RE: OSS:NWR: CLATSOP COUNTY: SITE NORTHWEST REGION
EVALUATION REPORT: TWN 7N, RNG 9W, SEC 4,
TAX LOT 201.

SITE EVALUATION - FIELD NOTES

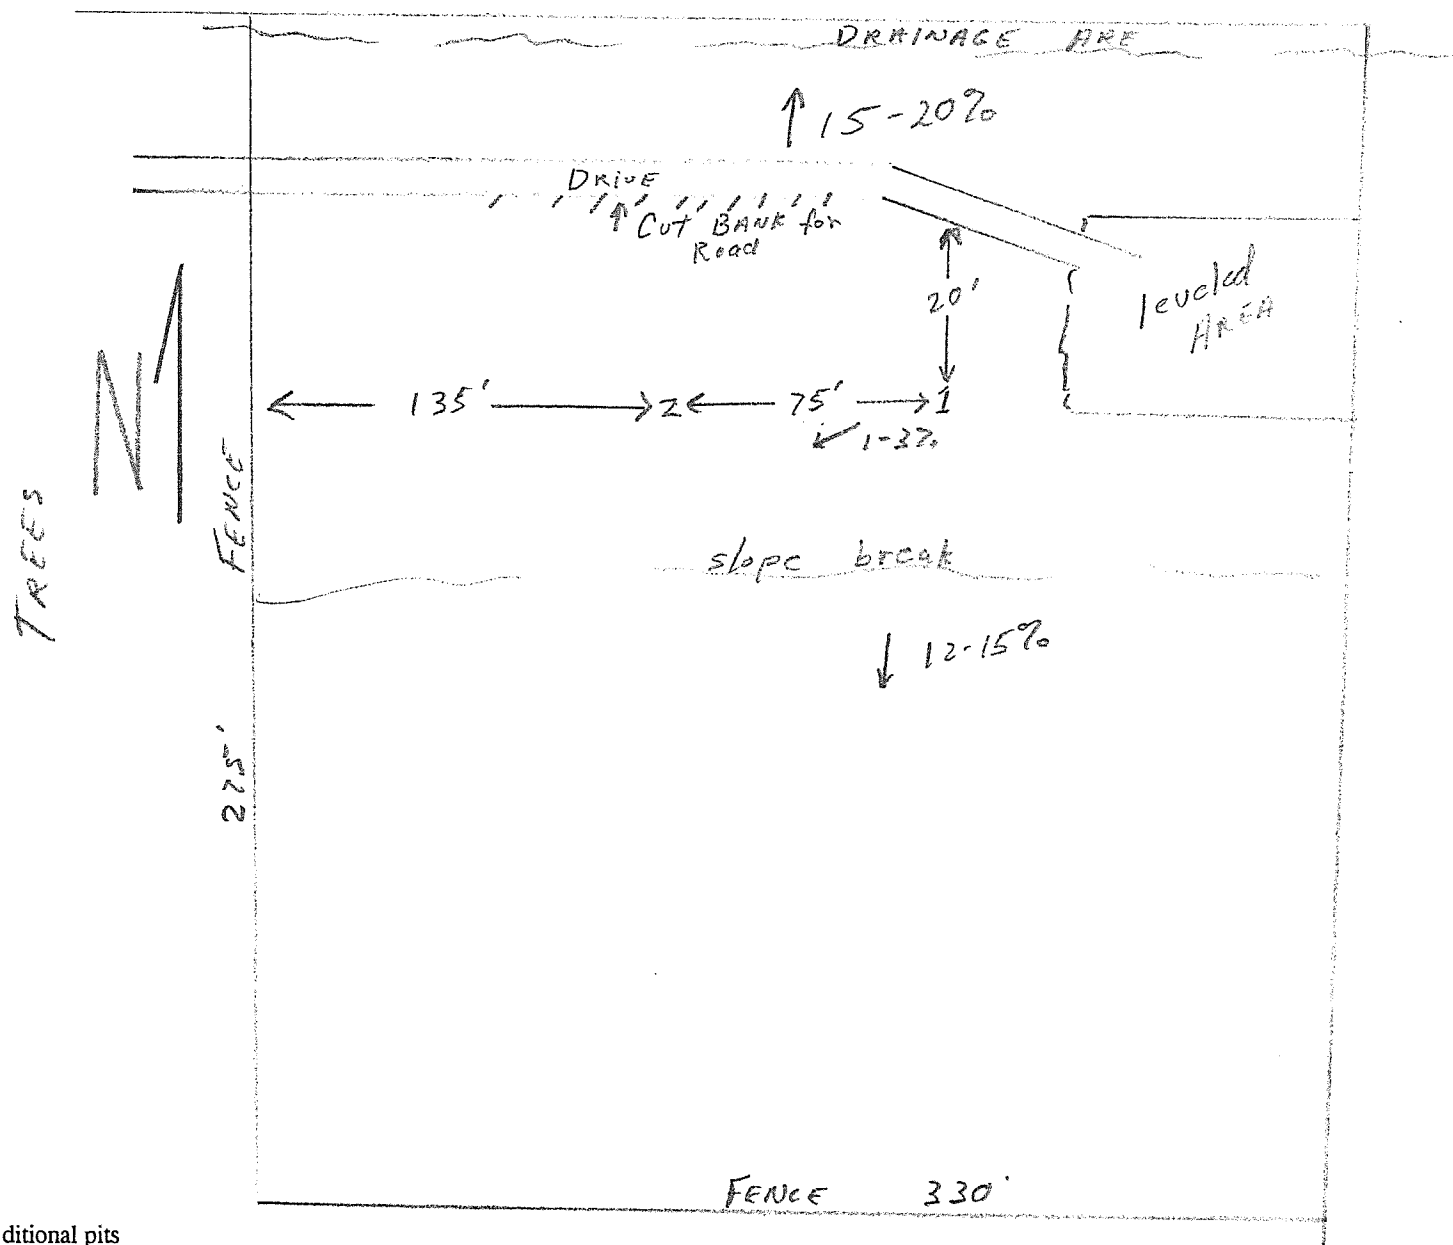
1 0-8 organic - profile depth ranges from 4-10"
8-14 sic-c 5/glyr sbk-massive w/ 5/SBG/1
14-62 c variegated greys & reds massive

notes Temp H₂O @ ~ 6"

2 0-7 sil 7.5yr^{3/2} sbk may fine roots
7-12 sicl 10yr^{3/2} sbk few fine " - very irregular boundary
12-20 sicl 10yr^{4/2} sbk vf vf roots - sticky - plastic
20-24 c 10yr^{5/1} w/ 5/glyr mottles sbk -
24-60 c variegated reds & greys - sbk-massive

notes Temp H₂O @ 7-12"SLOPE 1-3% ASPECT WGROUNDWATER NA; TEMPORARY; PERMANENT

Preliminary Site Development Plan

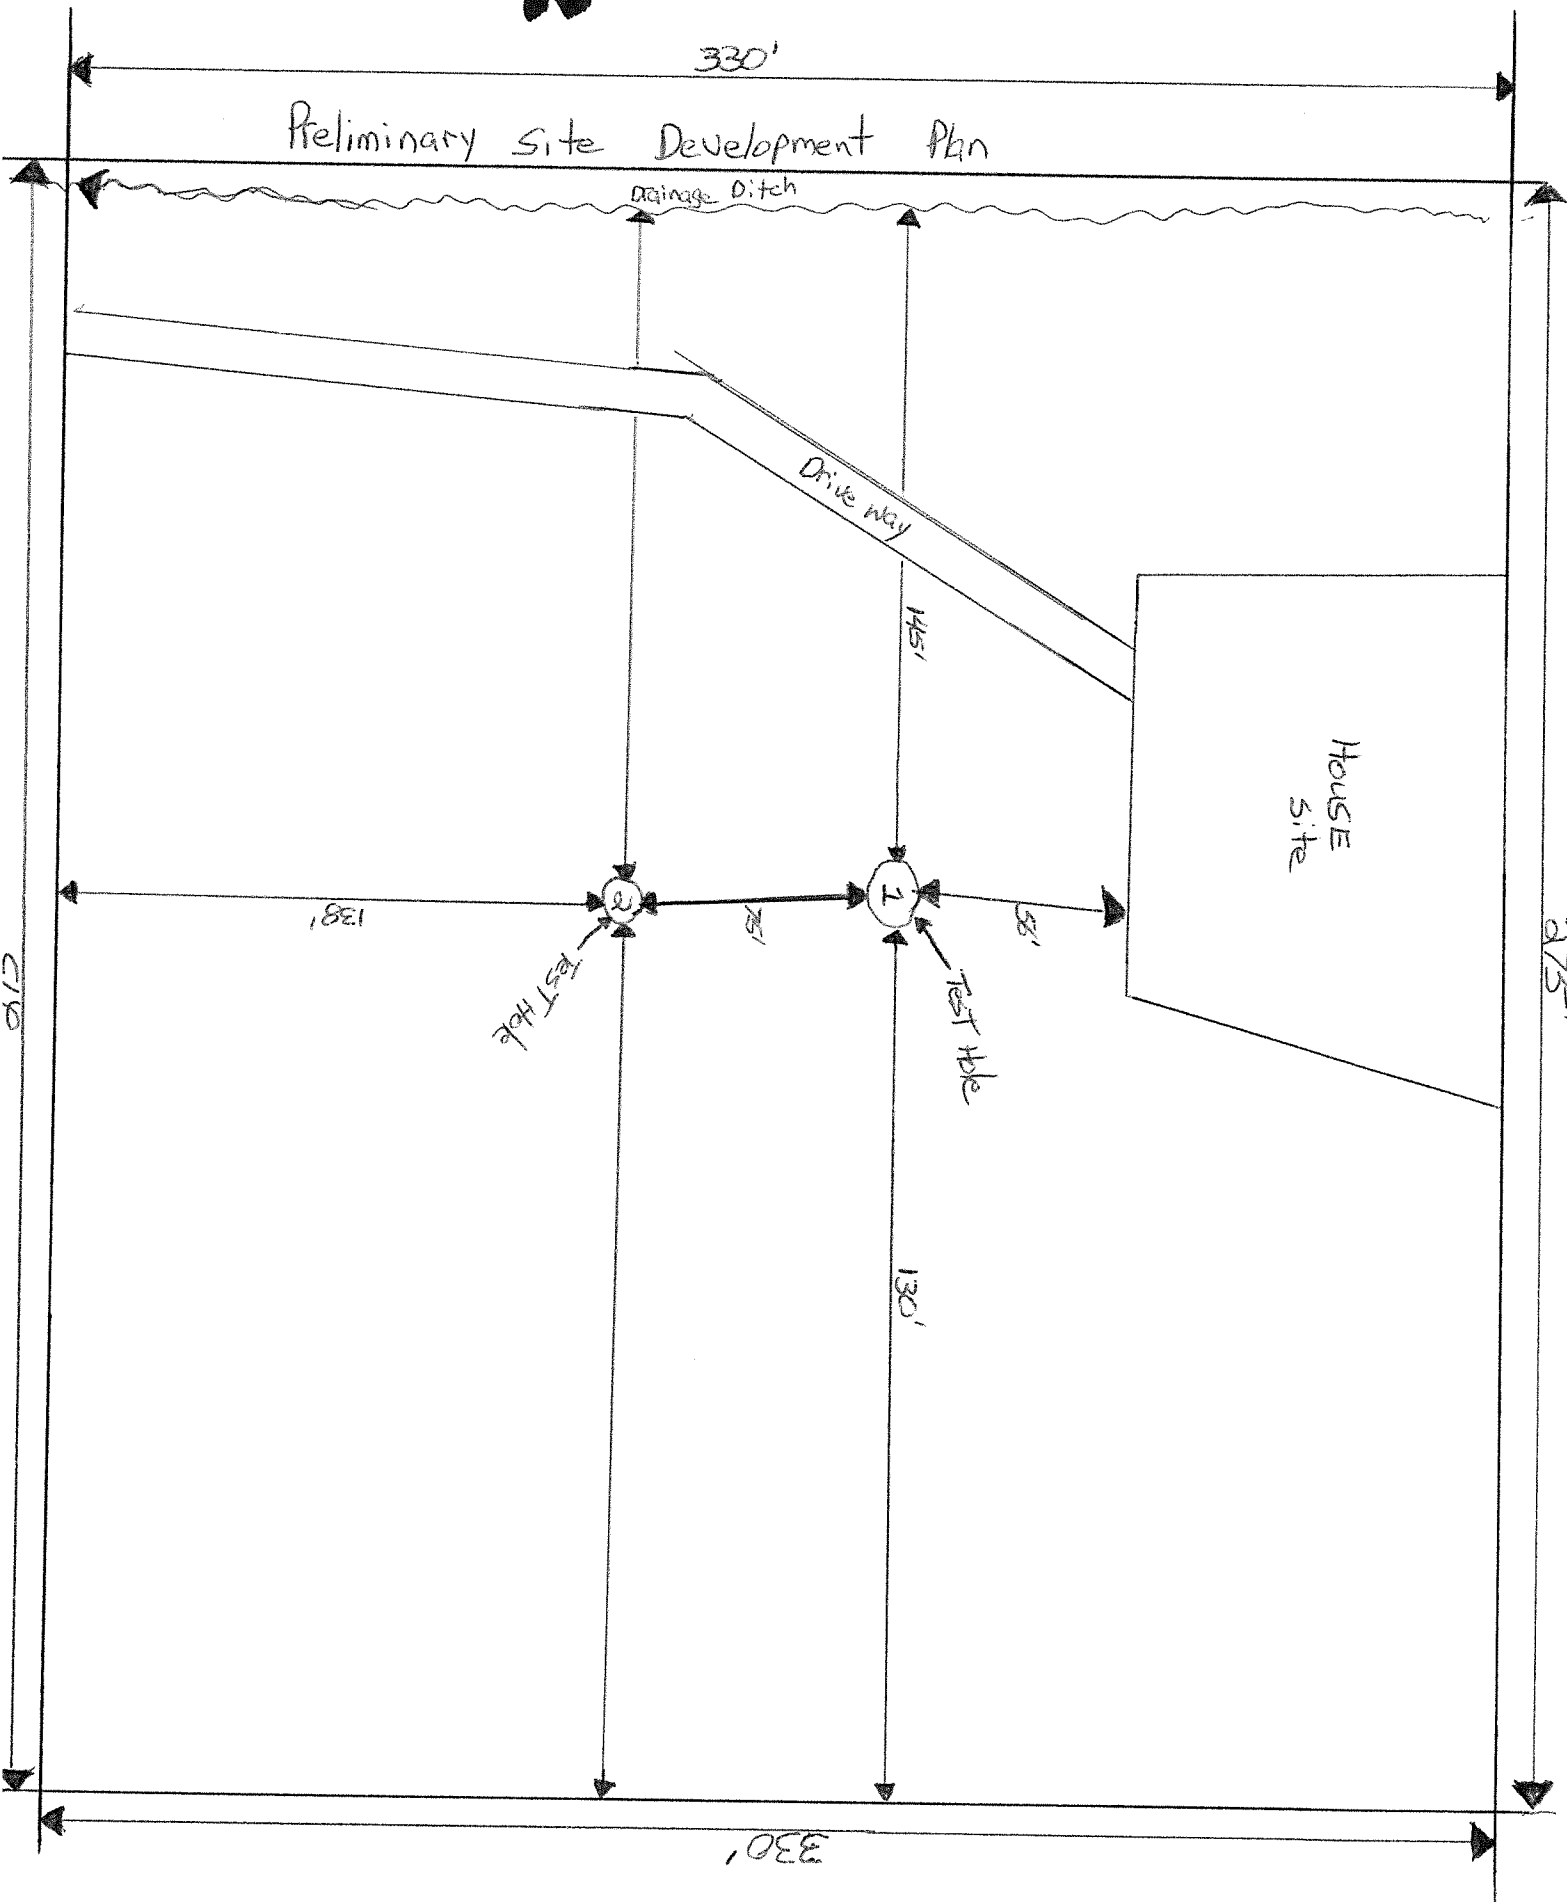
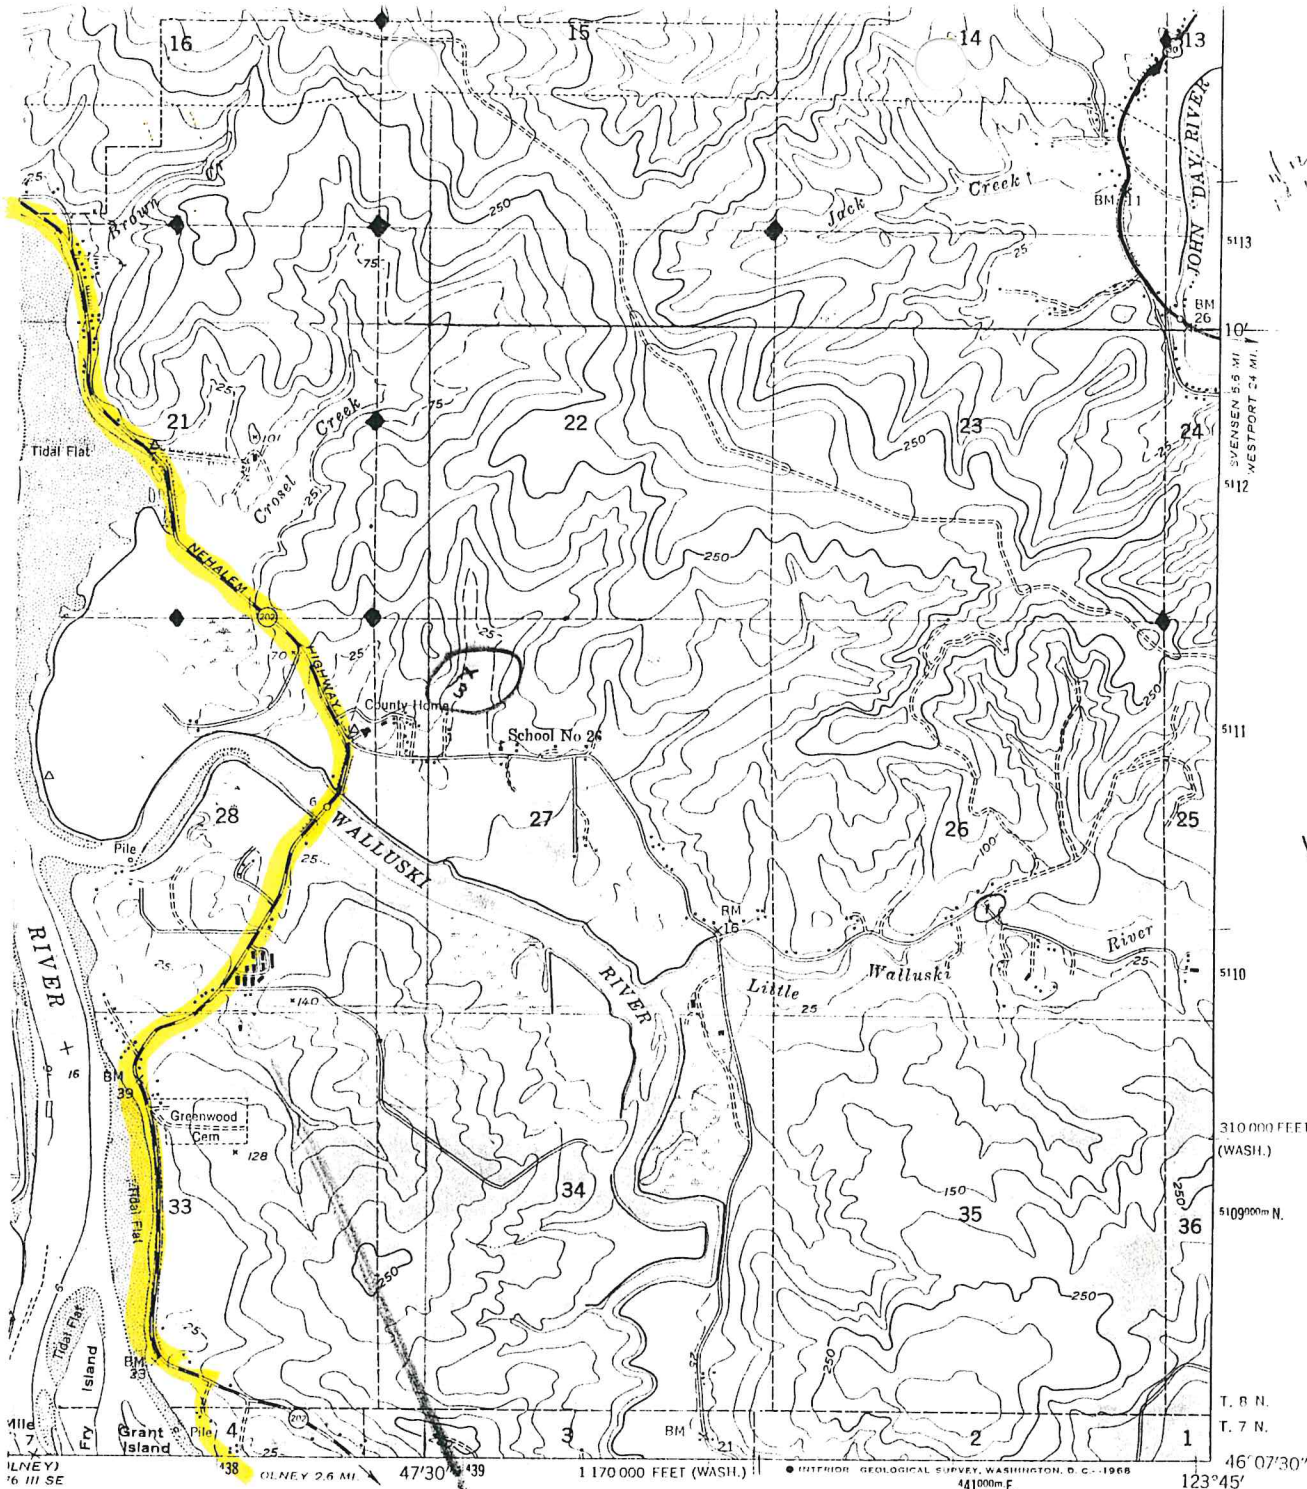
The two pits located on the property, were found to have soils that consist of silty clays and clay. The natural slope in the area of the pits was found to range from approximately 1 to 15 percent. Please refer to the enclosed field worksheet for information about the site observations.

1. OAR 340-71-220 (1)(b)(B), which requires that temporary groundwater be at least 24 inches below ground surface before a standard drainfield system can be installed. As we discussed during the time of evaluation, soils on this site indicate temporary groundwater to be within 6 to 10 inches of the ground surface during the wet time of the year.
2. OAR 340-71-290,(3)(a)(A), which allow the temporary ground water to be as close as 12 inches to the surface of the ground, if a sand filter is utilized as part of the sewage disposal system. However as noted above, the groundwater on this site can be expected within 6 to 10 inches of the surface.

The property has limited area available for on-site sewage disposal as noted above and as we discussed on site. It may be useful to dig new pits closer to the fence to the west, however the soils are very limiting on this property. After 90 days, any request for review will require a new evaluation application and necessary fees. The property will be evaluated using DEQ rules in effect at the time of this new application.
